Date of Document	18/10/24
Originator	Ian Chalmers
Originator's Ref (if any)	
Document Title	Musselburgh Flood Protection Scheme MLS report - Appendix A.14

Statement of My Reasons of Objection to The Musselburgh Flood Protection Scheme

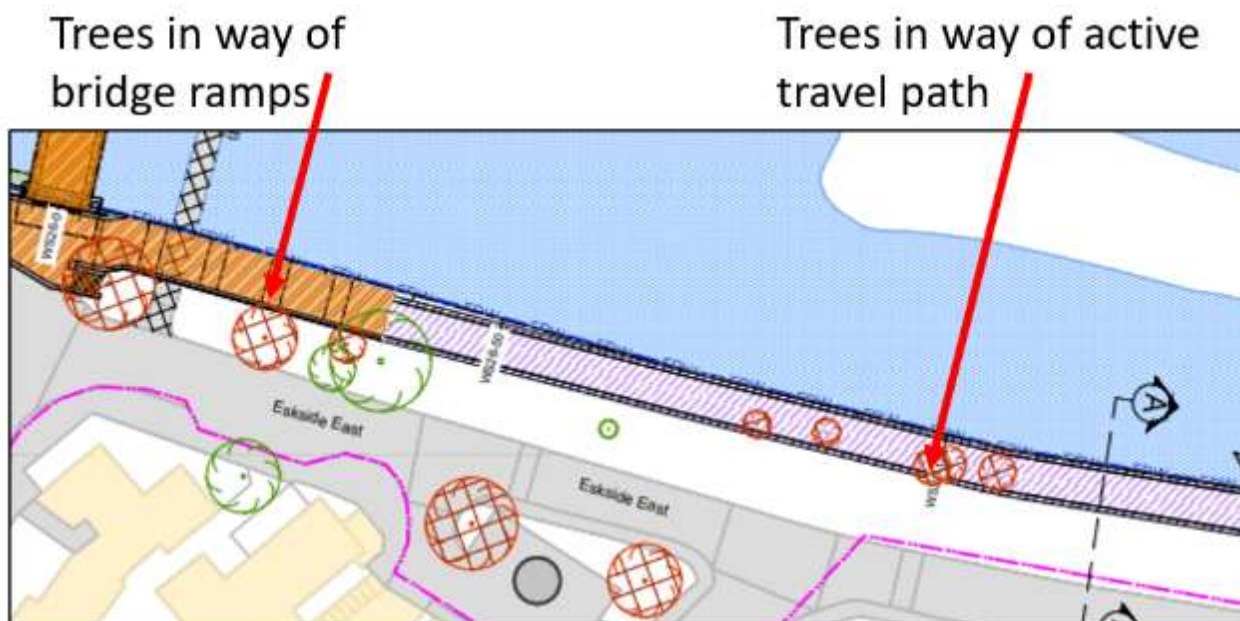
The other bridges further downstream have single ramps on the west side and double ramps on the east side of the river. The MAT caused this design element. The MAT route is to go along the east side of the river. If a bridge had a ramp only going down in one direction, this would be fine in normal circumstances. Having a double ramp does not give any flood risk reduction. The only reason for double ramps is to allow the MAT route to continue uninterrupted. The council are trying to circumvent the proper planning processes for MAT. They are 'pretending' that the bridge ramps elements of the flood scheme are nothing to do with MAT but this is simply not credible.

The drawings also show which trees they are planning on chopping down. A lot of them will be in the way of bridge ramps, walls or embankments. However there is a stretch of the river where the trees marked in red are not next to either. The only explanation for them being marked in red is that they are sitting where the 5 metre active travel path is planned. And yet MAT has been removed from the Flood Scheme. Odd!

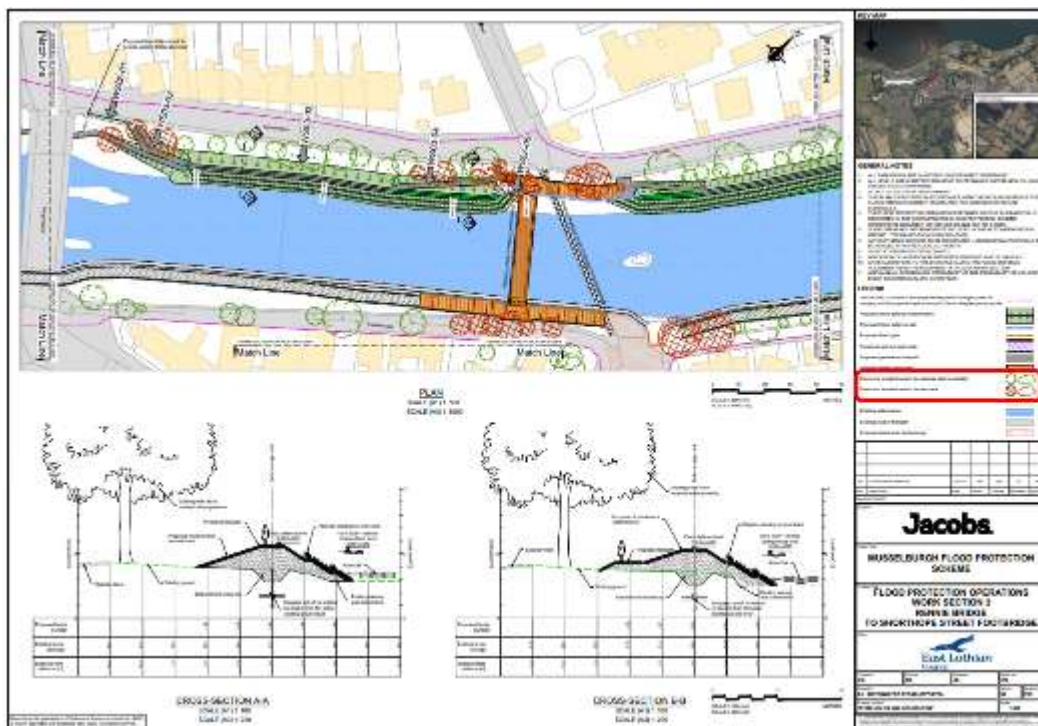
So let's talk about the trees for a moment then. Prior to June 2023 [redacted] advised me that they had taken from the consultations that the number one priority from the public was the height of the walls. However, after the Outline Design was published in June, it became obvious that the trees were as or more important based on the huge public outcry and significant protests – people tying ribbons round trees and generally getting very upset. The June 2023 drawings had a system for showing people which trees they were going to chop down. They marked all the trees in red and green. They marked clearly next to them 'Trees shown in green to be retained' and 'Trees shown in red to be removed'.

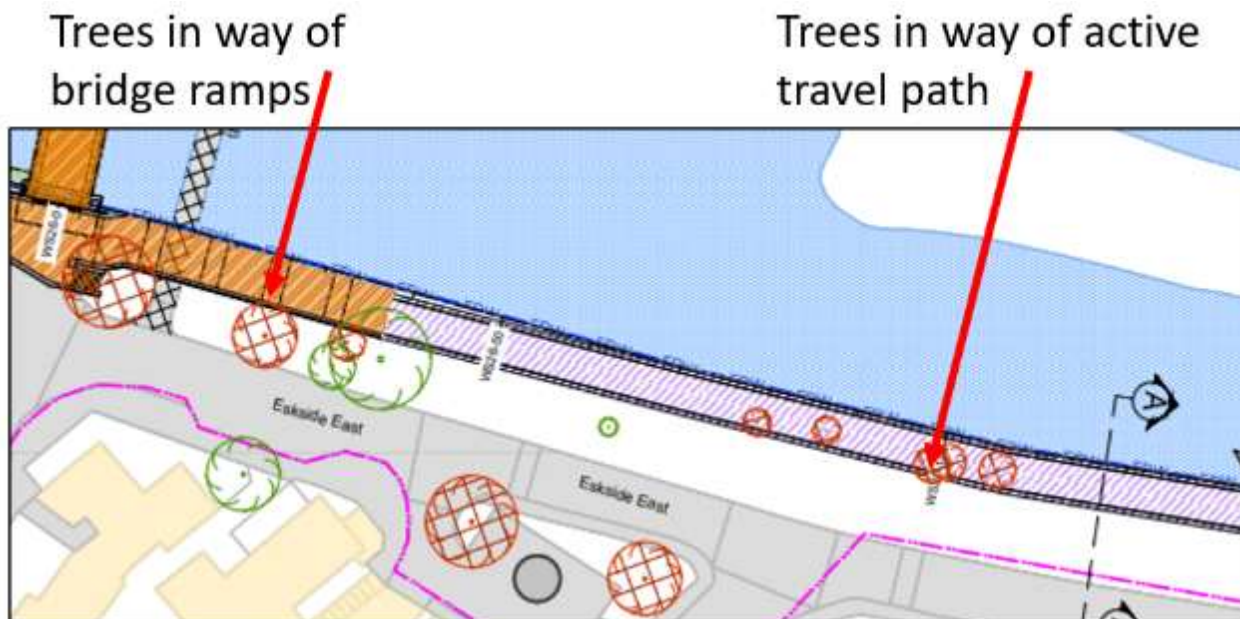
The other bridges further downstream have single ramps on the west side and double ramps on the east side of the river. The MAT caused this design element. The MAT route is to go along the east side of the river. If a bridge had a ramp only going down in one direction, this would be fine in normal circumstances. Having a double ramp does not give any flood risk reduction. The only reason for double ramps is to allow the MAT route to continue uninterrupted. The council are trying to circumvent the proper planning processes for MAT. They are 'pretending' that the bridge ramps elements of the flood scheme are nothing to do with MAT but this is simply not credible.

The drawings also show which trees they are planning on chopping down. A lot of them will be in the way of bridge ramps, walls or embankments. However there is a stretch of the river where the trees marked in red are not next to either. The only explanation for them being marked in red is that they are sitting where the 5 metre active travel path is planned. And yet MAT has been removed from the Flood Scheme. Odd!
